AP - 45

APPROVALS

EME P-6 LINE LEAK SITE
T20S - R37E - Section 6 - Unit P
RICE Operating Company

PROPOSED
BACKFILL
DIAGRAM

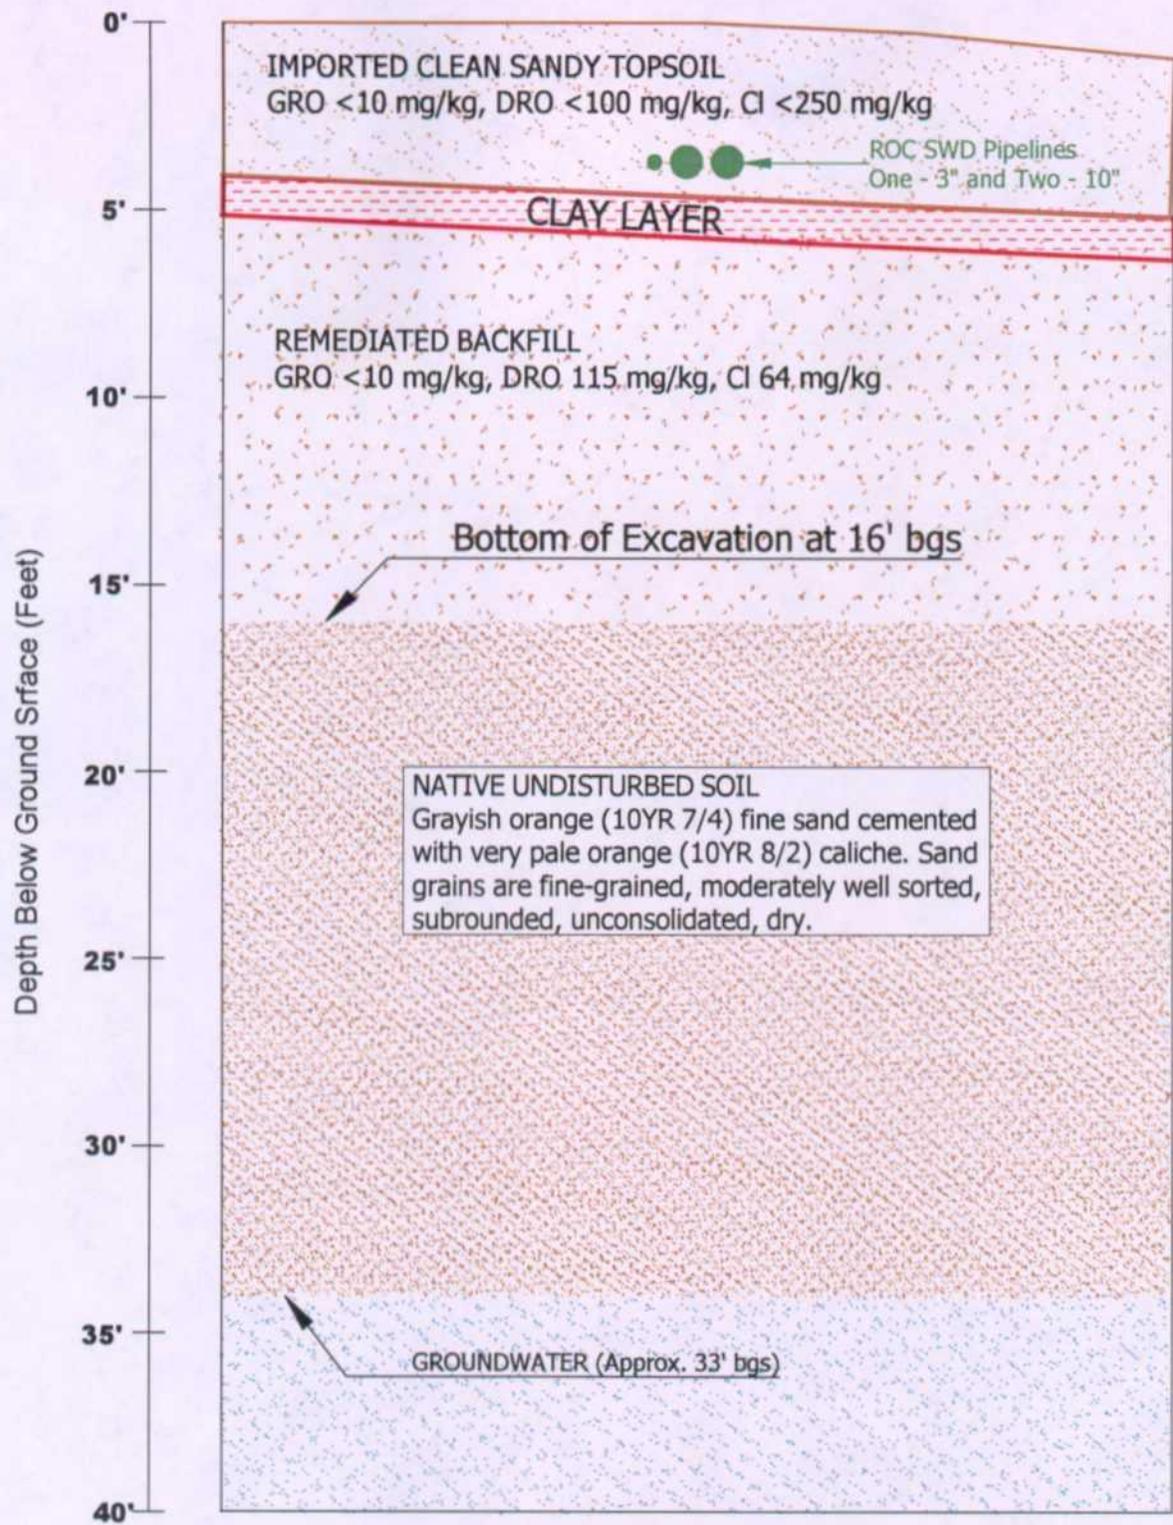
A diagram showing the North-South cross-sectional profile of the proposed backfill procedure is attached for your review. Various photos of the activities and lab reports are attached as well. We now seek your approval to begin backfilling with the remediated soil and overlay it with a clay layer and topsoil.

The NMOCD has reviewed the submitted data for the above referenced site. The NMOCD hereby approves proceeding with the proposed backfilling activities as reference below.
